<b>Title - Sujet</b> Construction Services	
<b>Solicitation No. - N° de l'invitation</b> EZ899-152249/A	<b>Amendment No. - N° modif.</b> 008
<b>Client Reference No. - N° de référence du client</b>	<b>Date</b> 2015-04-23
<b>GETS Reference No. - N° de référence de SEAG</b> PW-\$PWY-019-7491	
<b>File No. - N° de dossier</b> PWY-4-37355 (019)	<b>CCC No./N° CCC - FMS No./N° VME</b>
<b>Solicitation Closes - L'invitation prend fin at - à 02:00 PM on - le 2015-04-30</b>	<b>Time Zone</b> Fuseau horaire Pacific Daylight Saving Time PDT
<b>F.O.B. - F.A.B.</b> <b>Plant-Usine:</b> <input type="checkbox"/> <b>Destination:</b> <input checked="" type="checkbox"/> <b>Other-Autre:</b> <input type="checkbox"/>	
<b>Address Enquiries to: - Adresser toutes questions à:</b> Ngan, Ken (PWY)	<b>Buyer Id - Id de l'acheteur</b> pwy019
<b>Telephone No. - N° de téléphone</b> (604) 658-2755 ( )	<b>FAX No. - N° de FAX</b> (604) 775-6633

Project No. R.0171363.001

Addendum #004

Tender A – Pleasant Camp Port of Entry

SKS-001 - SITE PLAN

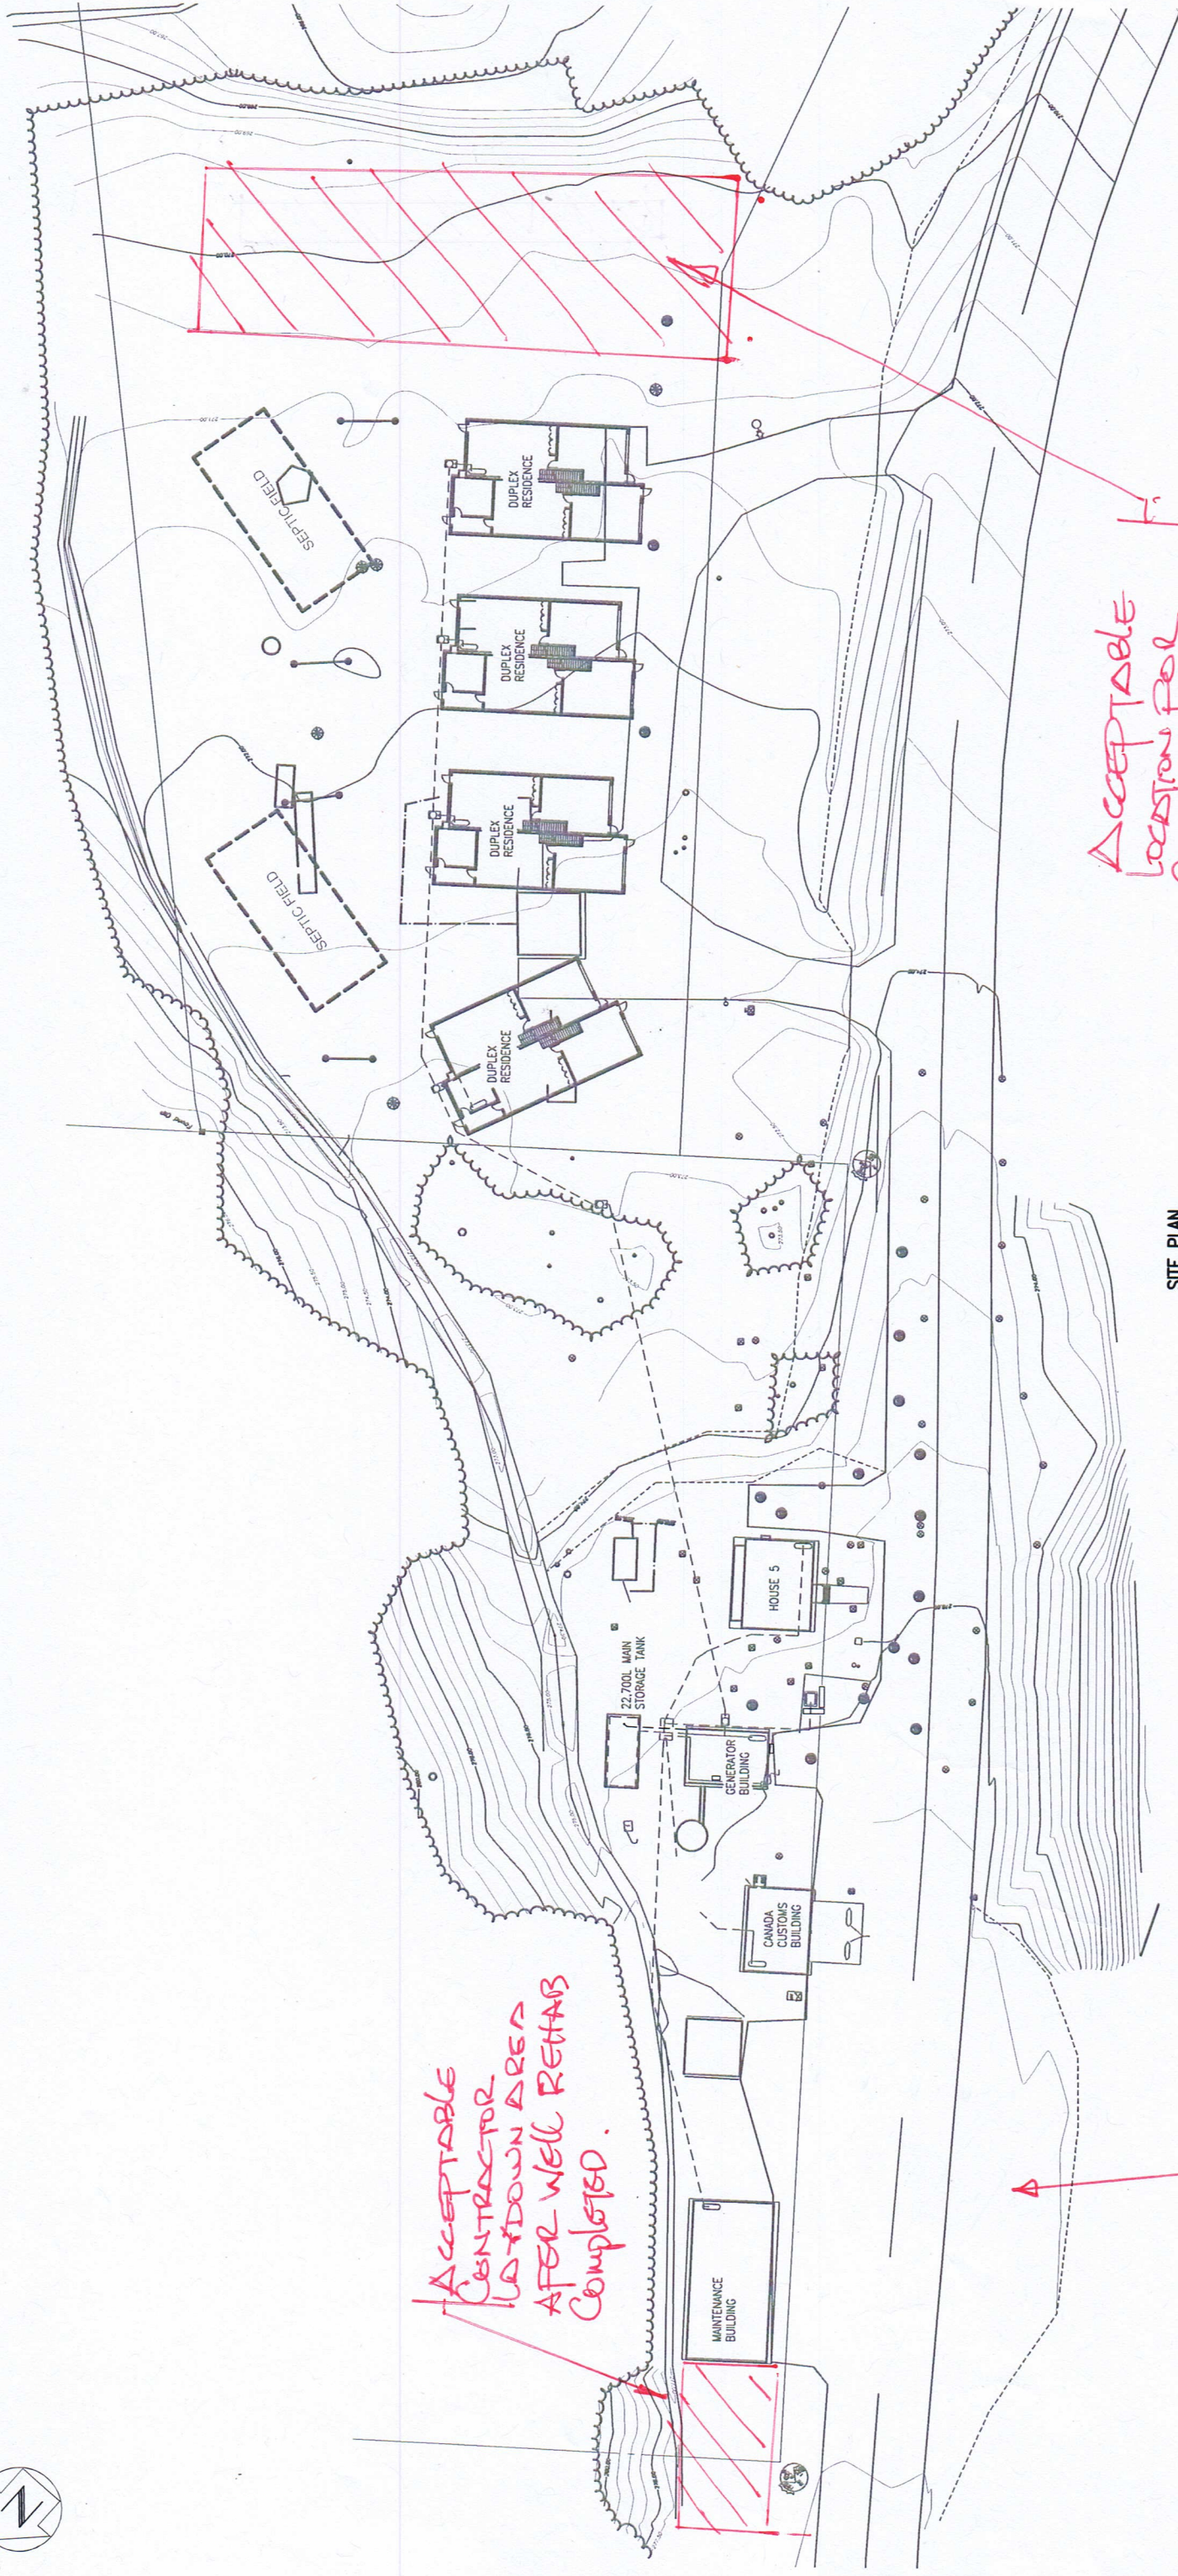
1. Question: Can we install a construction camp at site?  
Response: Yes - the Contractor can install a camp at the south end of the site as near to the trees as possible. The Contractor shall provide their own water and sanitary tanked services. Connection to site power and communication must be coordinated with the utility.  
Note that the proposed location is used as a snow dump for the site and the camp must be removed offsite prior first snow.

ACCEPTABLE  
CONTRACTOR  
LAYOUT AREA  
AFTER WELL RETARS  
COMPLETED.

ACCEPTABLE  
LOCATION FOR  
CONTRACTOR CAMP

DO NOT USE THIS AREA  
FOR LAYDOWN OR PARKING

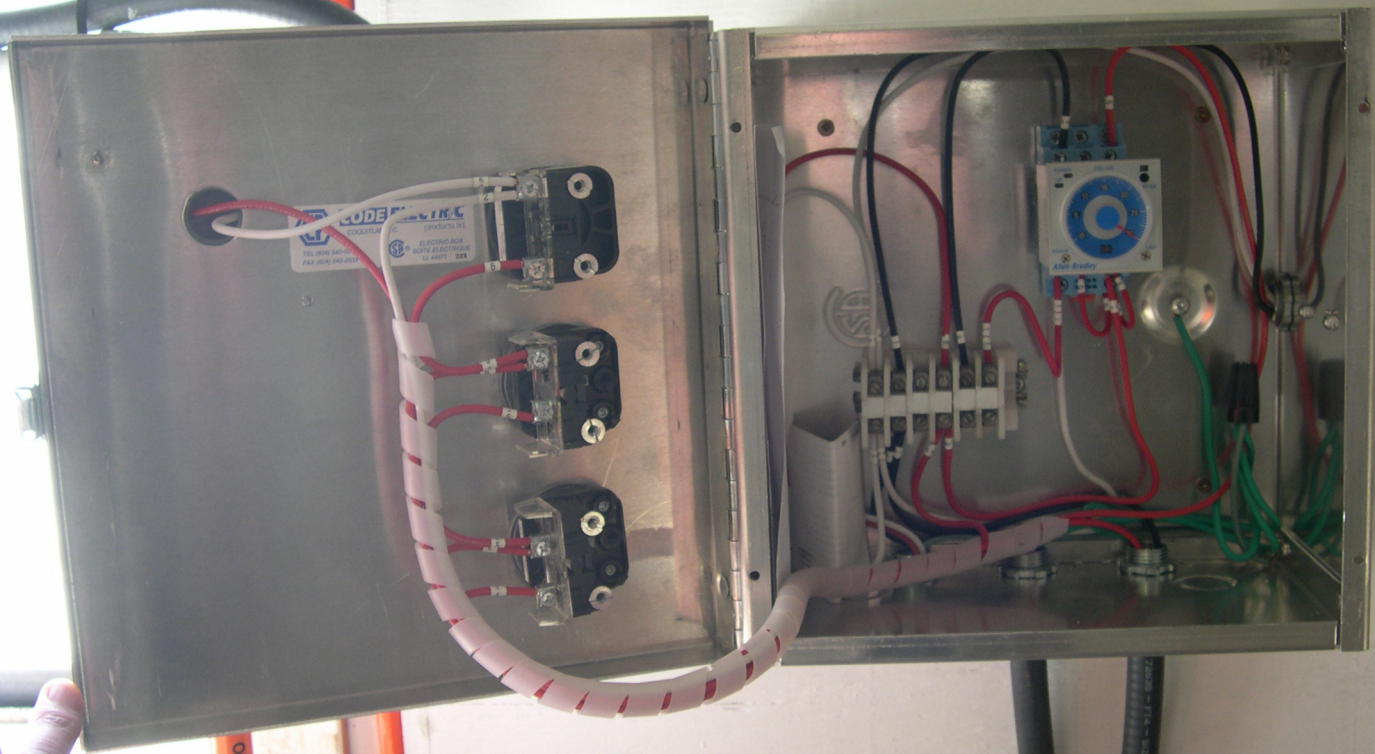
2. Question: Drawing F-008 " Building Fuel Tank Control Panel Schematic " we are being asked to install a new relay in four existing panels, what make are the panels?, do they have enough room?, how far is house #9?

Response: 1. Panel appears to be "Code Electric", unless that is the enclosure manufacturer. See attached photo.  
.2 There appears as if there should be room. See attached photos DSCN0002&3.  
.3 House #9 (former House #5) is approximately 65m south of the new site services building (center to center of building).
